The Commission has issued the enclosed Amendments No. 11 to Facility Operating Licenses Nos. DPR-32 and DPR-37 for the Surry Power Station, Units 1 and 2. The amendments include Change No. 26 to your Technical Specifications for each license and are in response to your request dated September 8, 1975, as supplemented October 22, 1975, and October 30, 1975.

The amendments revise the provisions in the Technical Specifications relating to the replacement of 81 of 157 fuel assemblies in the reactor core, constituting refueling of the core for third cycle operation of Unit 1.

ATTACHMENT TO LICENSE AMENDMENT NO. 11

CHANGE NO. 26 TO THE TECHNICAL SPECIFICATIONS

FIGURE 3.12-1A CONTROL BANK INSERTION LIMITS FOR 3-LOOP NORMAL OPERATION-UNIT 1

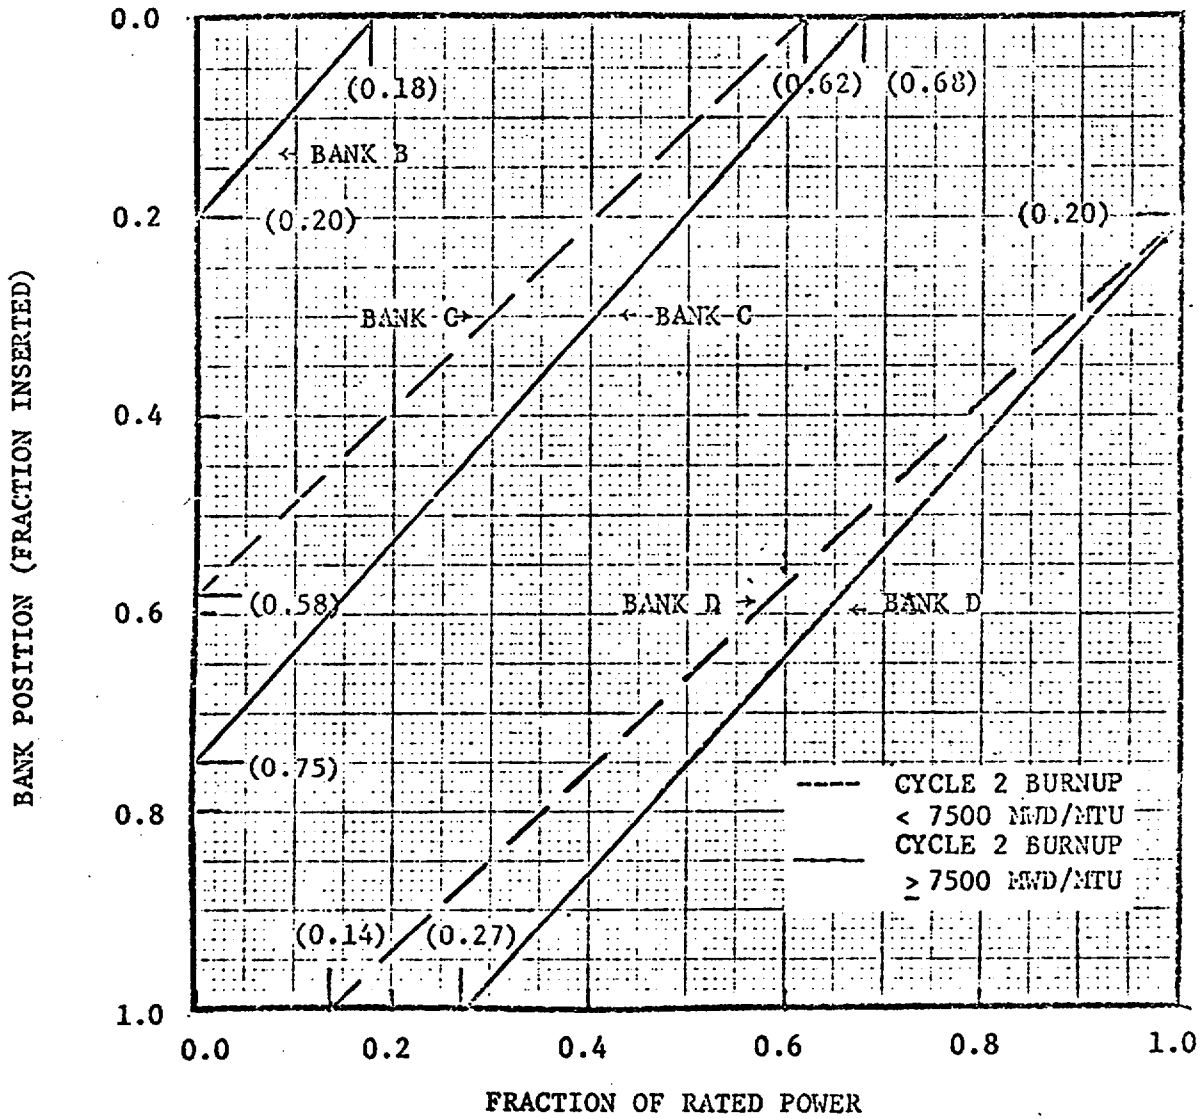
The specified control rod insertion limits have been revised to limit the potential ejected rod worth in order to account for the effects of fuel densification.

The licensee proposed to change the control rod insertion limits for Cycle 3 to provide more flexibility in control rod bank positioning of the Hot Zero Power (HZP) critical position and in going from HZP to power operation. He has evaluated these insertion limits for conformance with the following design limiting criteria:

FIGURE 3.12-1A CONTROL BANK INSERTION LIMITS FOR 3-LOOP
NORMAL OPERATION-UNIT 1

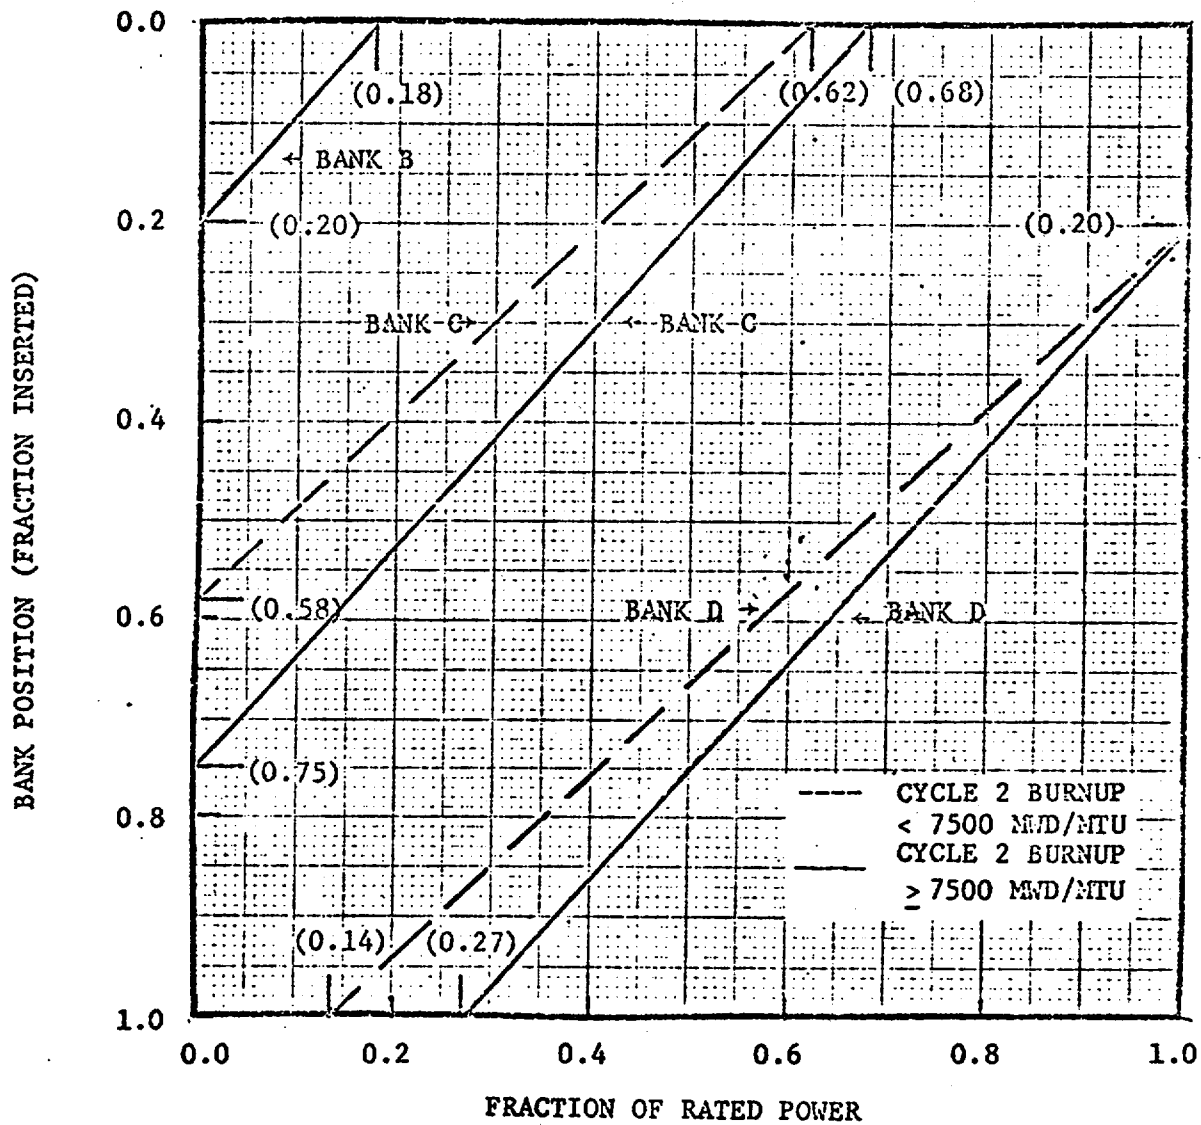
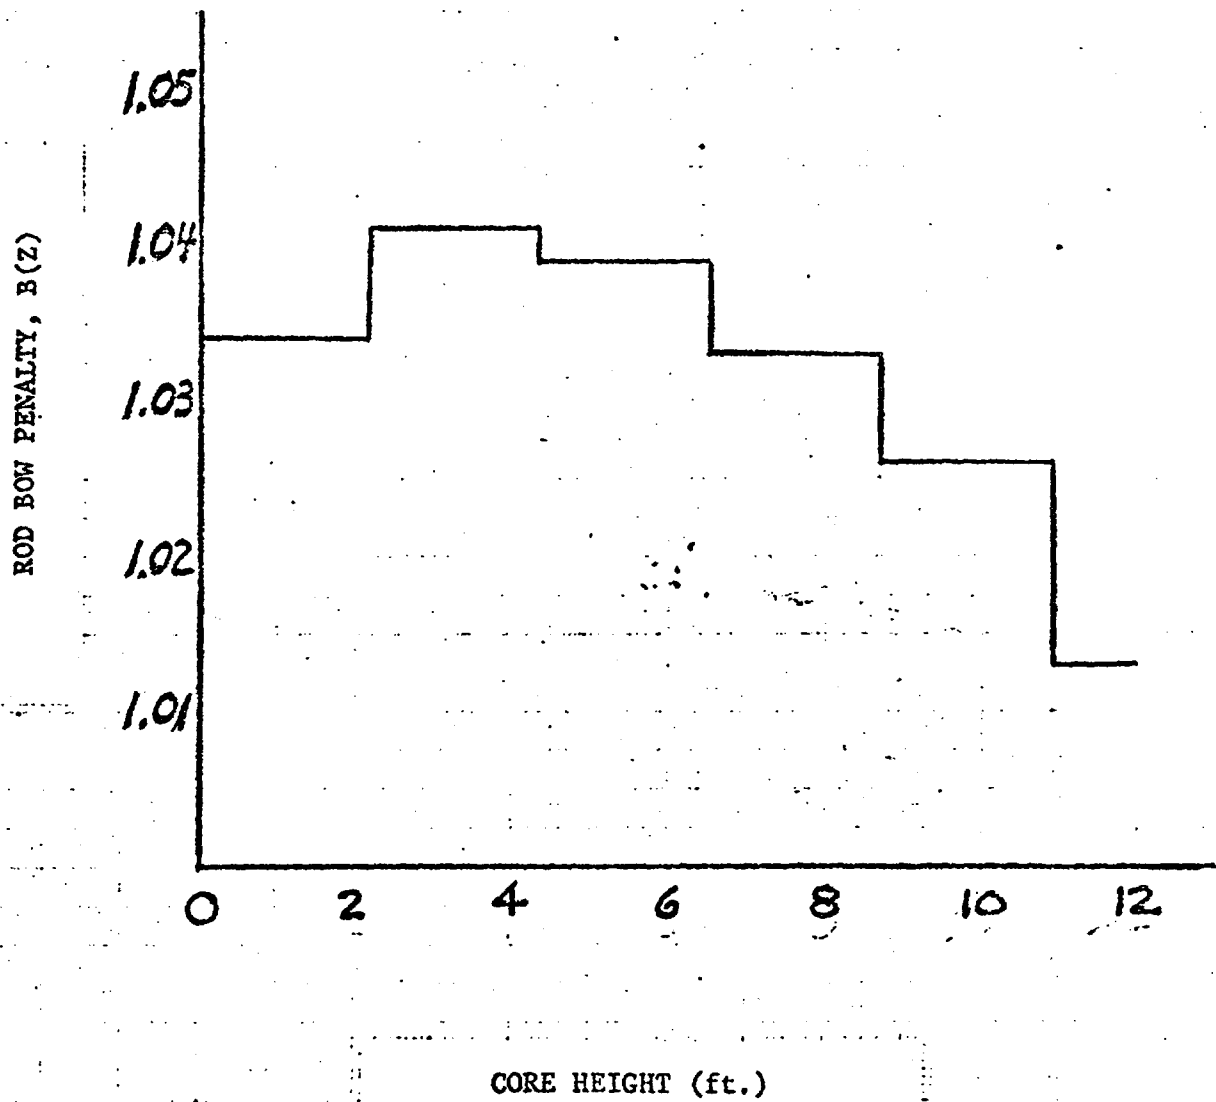
The specified control rod insertion limits have been revised to limit the potential ejected rod worth in order to account for the effects of fuel densification.
